**PUD-96**  
**Exhibit A, Discussion Points for the Planning Commission**

**The Commons at Gateway**  
**1600 Valley Avenue**  
May 22, 2013

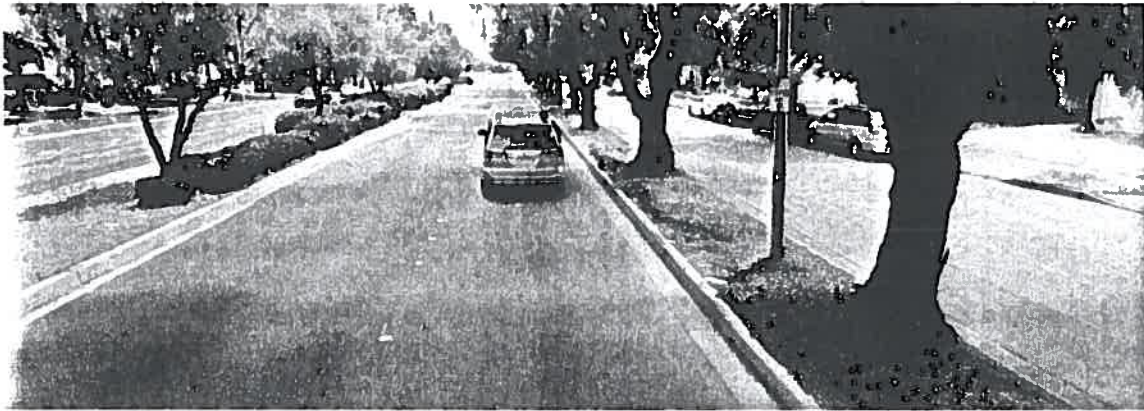
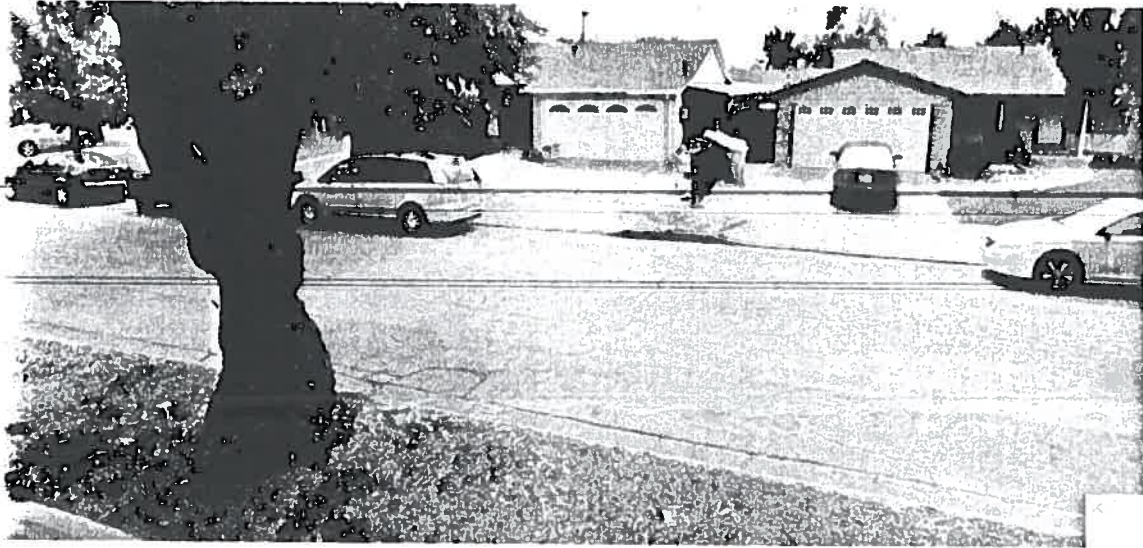
I am giving a picture below of the Stevenson blvd (near 880) in Fremont. This is an old development more than 50 years ago yet they took care of the safety of the homes, which faced Stevenson blvd by separating the Stevenson blvd and the homes by adding an additional lane just for the community. And this was planned 50 years ago.

(The above picture shows the Stevenson Blvd in Fremont which has additional lane on the right side just for the community whose homes are facing towards the road. )

(Another view of the road in front of the homes, which is exclusive to the community)

(homes facing valley ave) [source:google map](#)

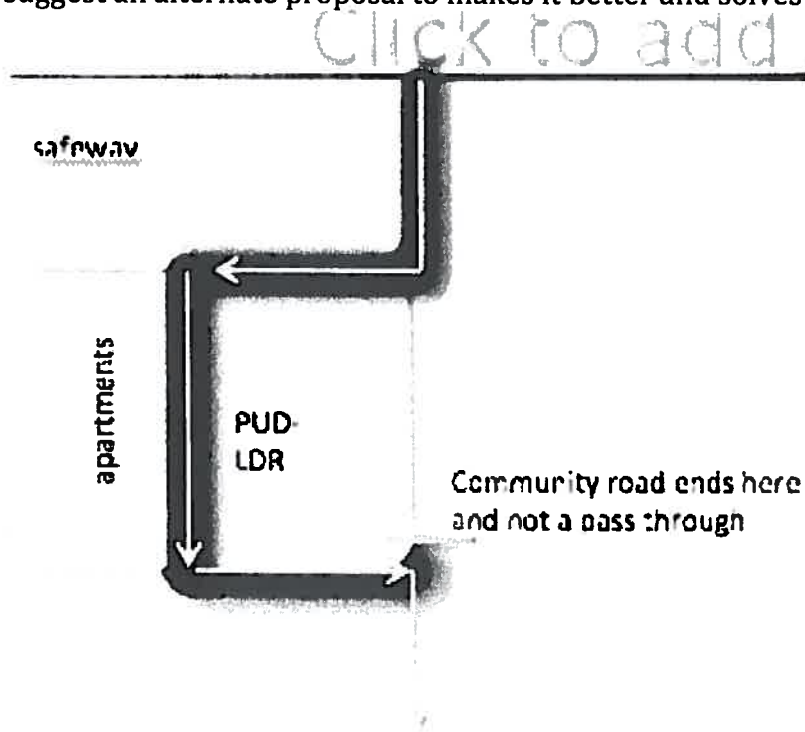
I want to correlate a similar thing in Pleasanton next to this PUD-96. Houses are built facing the valley ave (in my opinion this should have never got approved in the first place). Now the valley ave (from bernal to case ave) has become a main street it is not a community road anymore. With the new PUD, it is going to be even worse and puts the homes and kids in those homes at dangerous risk. I am surprised that a city like Fremont solved a problem/issue over 50 years ago and city like Pleasanton failed to execute where quality comes first. (We went back in years with respect to planning)
